# 1973 Corvette: Service Bulletin: Exhaust Manifold Heat Shielding

73-T-8

**Subject:** EXHAUST MANIFOLD HEAT SHIELD -  
 1973 CORVETTE WITH 350 CU. IN.  
 ENGINE WITH AIR CONDITIONING

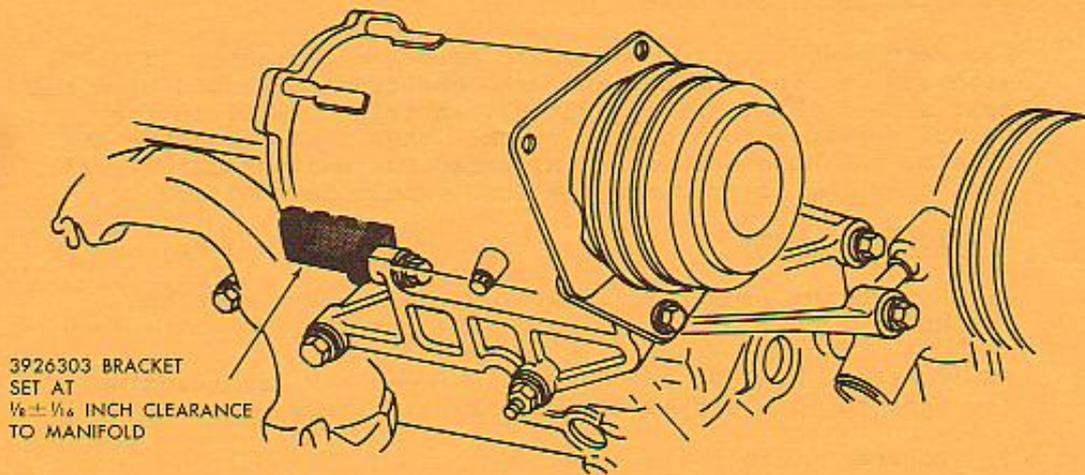
Some early production 1973 Corvettes equipped with 350 cu. in. engines and air conditioning may experience air conditioning hose damage due to close proximity of the exhaust manifold.

Corvettes assembled after September 13, 1972, have a heat shield installed between the hose and the manifold to protect the hose from heat.

For service, Corvettes assembled prior to September 13, 1972, with 350 cu. in. engines and air conditioning should have the heat shield, Part Number 3926303, installed while in for normal service or in dealer stock. When installing the heat shield, the hose should be inspected for heat cracking. If heat cracking is evident, the hose should be replaced.

- 1) Remove nut from rear compressor to bracket mounting bolt.
- 2) Position bracket on bolt and between air conditioning suction hose and manifold as illustrated.
- 3) Torque nut to 25 ft. lbs.
